**PLANNING STATEMENT**

**TO ACCOMPANY A PLANNING APPLICATION  
SEEKING OUTLINE PLANNING PERMISSION  
FOR RESIDENTIAL DEVELOPMENT  
INCLUDING DEMOLITION OF 89 COURT ORCHARD**

**ON LAND AT HOLYWELL FARM  
AND 89 COURT ORCHARD  
WOTTON UNDER EDGE**

### TOWN AND COUNTRY PLANNING ACT 1990 HIGHWAY RECOMMENDATION

Drawing No. 151158/SKT03 Revision B

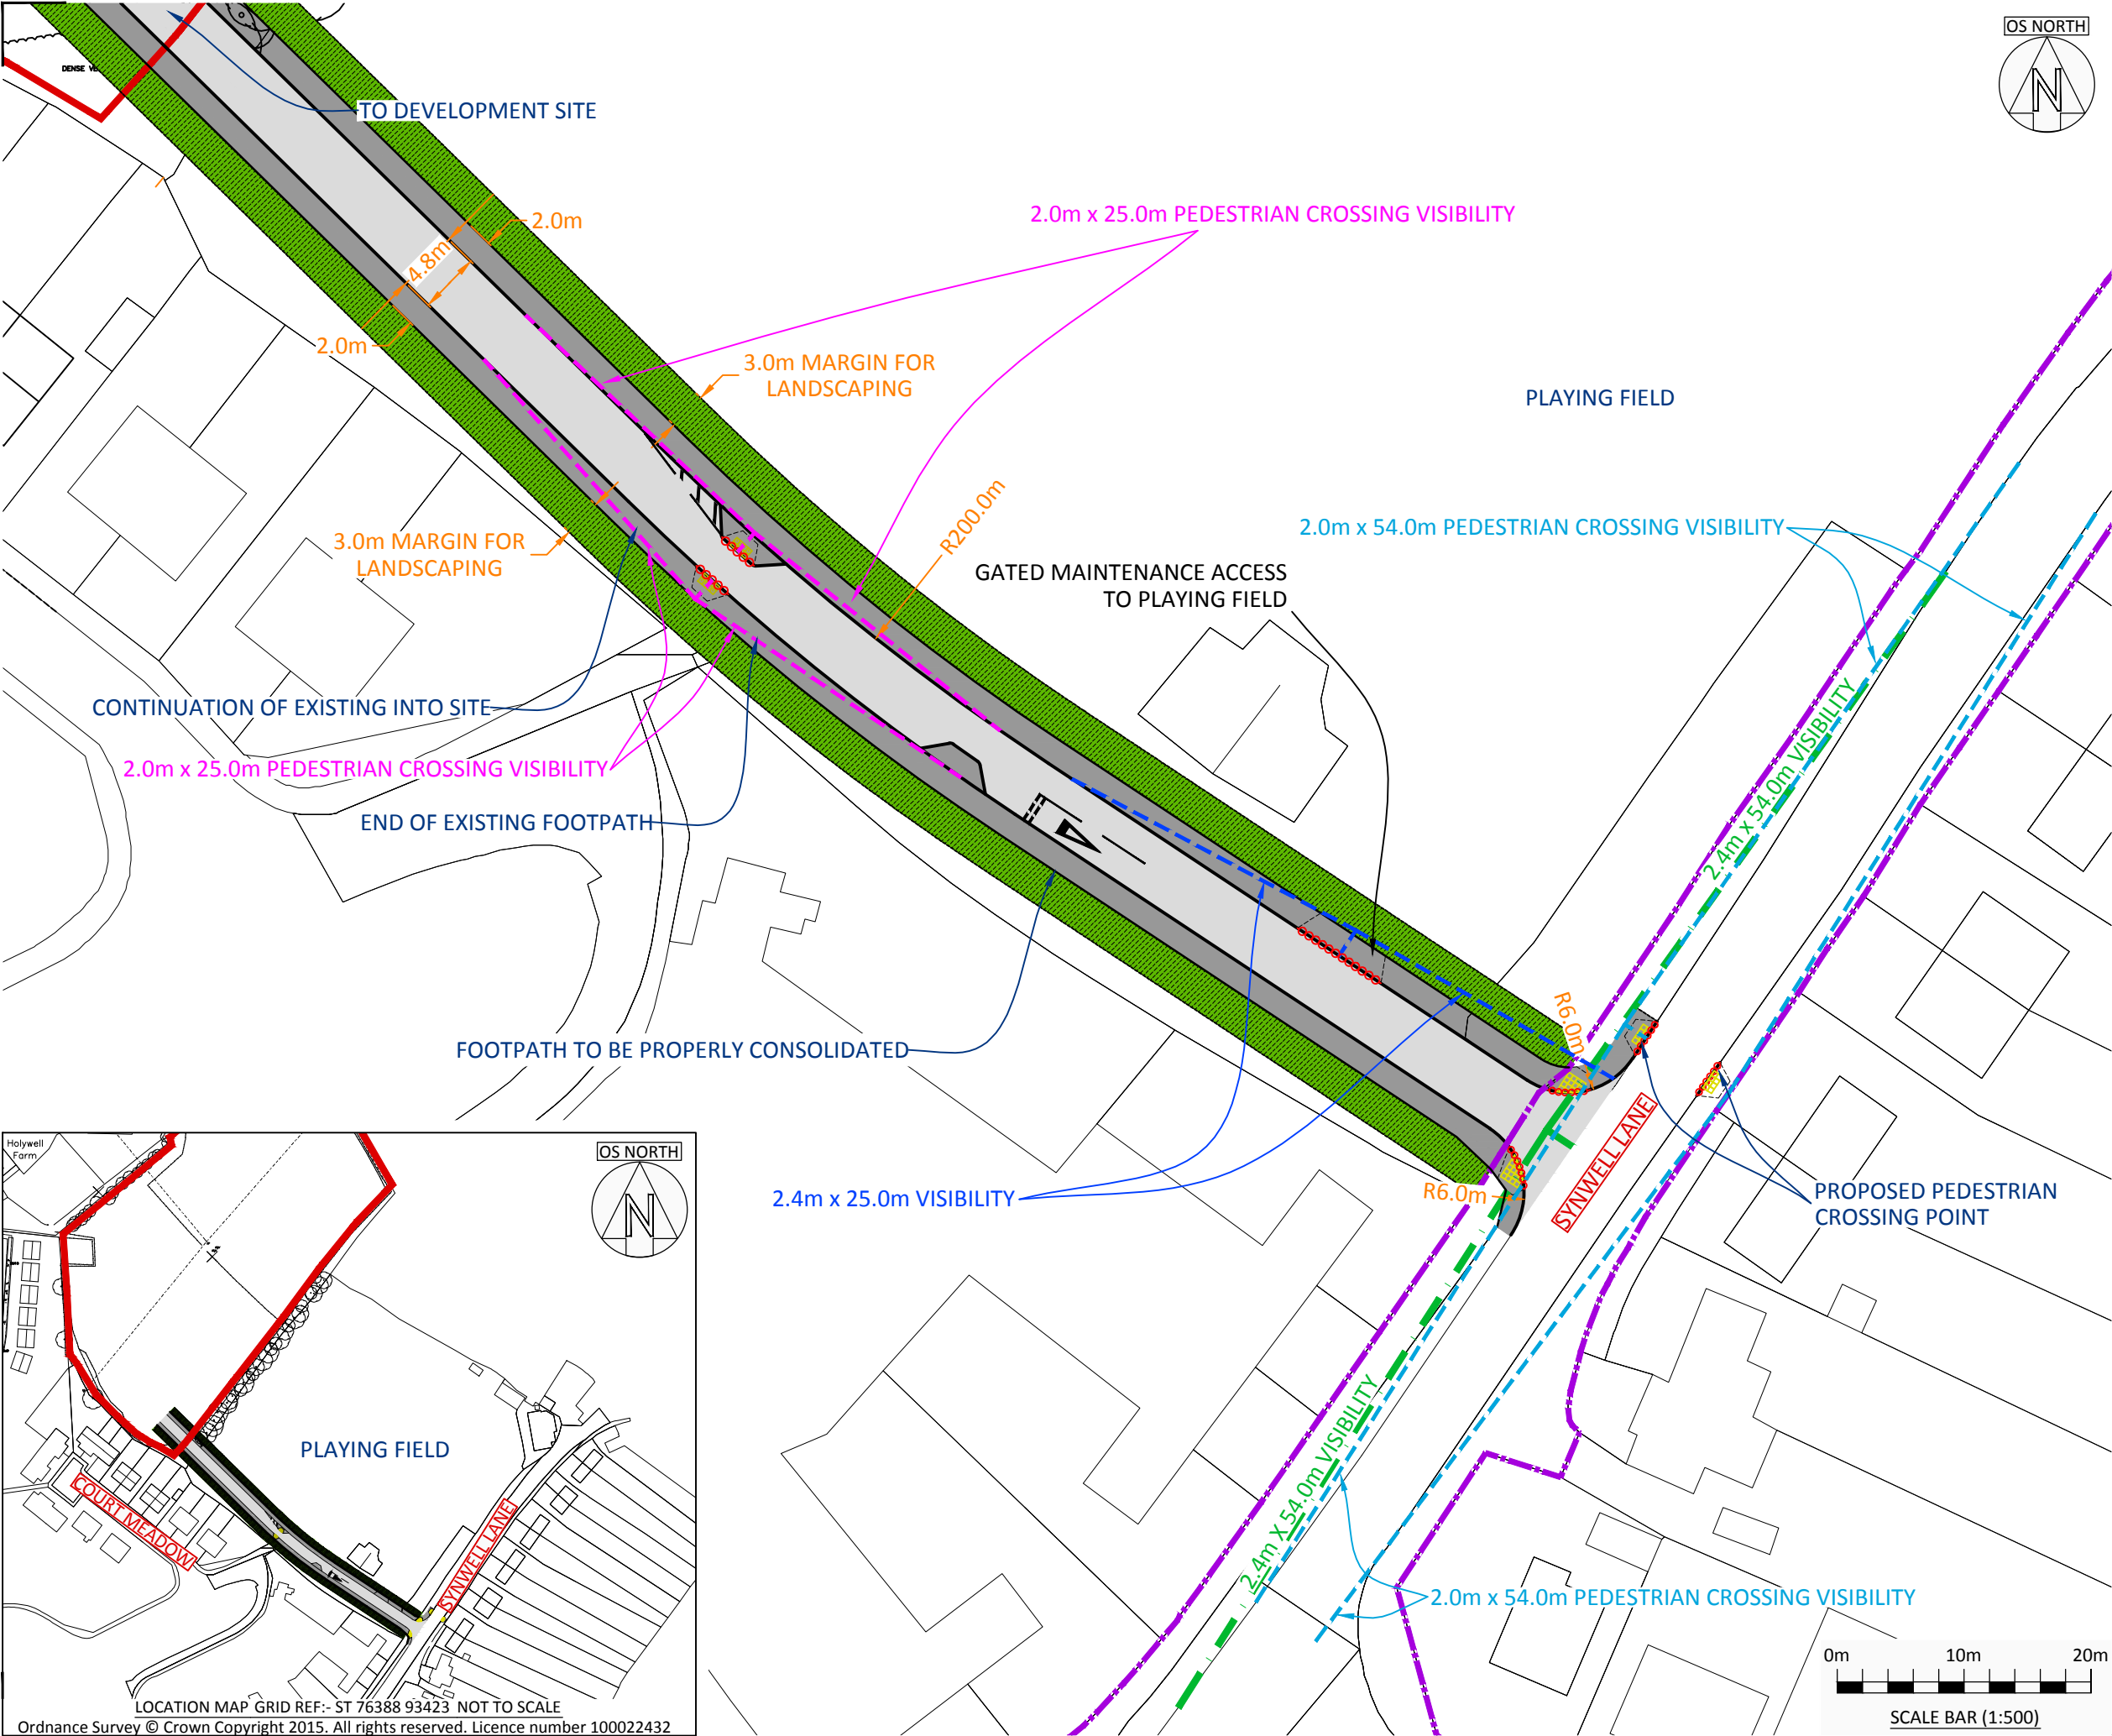
Forward visibility should be complaint to the recommended design guidance within MfGS.

Initial observations are that the forward visibility has been measured incorrectly, going from ~1.5m on the nearside to ~1.5m to the offside. Forward visibility should be ~1.5m around the inside of the bend or in accordance with figure 7.19 MfS.

I have a minor concern regarding the boundary location of the adjacent property. I am concerned that the proximity of the boundary may affect pedestrian visibility around the bend.

Drawing No. 151158/SKT01 Revision C

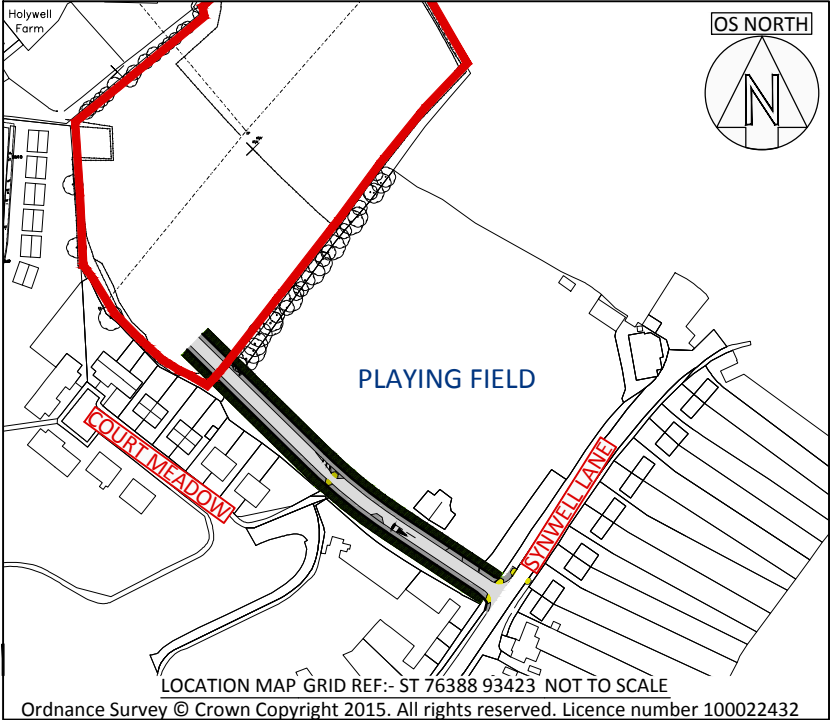
Drawing 151158/SKT01 has proposed a speed control feature. Any speed reduction feature should be designed to a target speed of 15-20mph in accordance with table 5.7 MfGS. TA87/04 states that kerb build outs reduce carriageway width; shelter permitted parking and provide a reduction in pedestrian crossing width. The most suitable form of speed control for this development would be two kerb build outs to form a chicane; the build outs could contain a bollard or tree. The chicane therefore reduces speed in either direction, unlike priority builds out on one side of the carriageway which does not encourage reduced speed for the priority lane. The chicane should be tracked for the largest expected vehicle to enter the development in order to demonstrate that the vehicle would not be in conflict. Furthermore, the slight bend in the 4.8m carriageway may create a conflict between a passing HGV and car, therefore a swept path analysis of a HGV, most likely to be a 3 axle refuse vehicle and estate car measuring 1715mm x 4223mm passing throughout the length of the access road would be recommended at full application stage.

The lane width between the edge of the build out and edge of carriageway is not annotated but appears to be approximately 2.75m in width. LTN 1/07 6.1.6 states that total widths though narrowings of between 2.75m and 3.25m should be avoided if no cycle bypass is provided. Within this range some motorists will attempt to overtake cyclists even if there is not sufficient width to do so, therefore risk of conflict would be potentially significant.

As a result I would decrease the build outs to allow a carriageway width of 3.25m (Annotated on the plan), and to remain as an affective speed reduction feature, the staggered can be reduced with tracking submitted to demonstrate suitability. LTN 1/07 table 6.1 – 6.3 and fig 6.5 provide some helpful information regarding suitable chicane layouts.

The chicanes should include protection bollards and lighting.
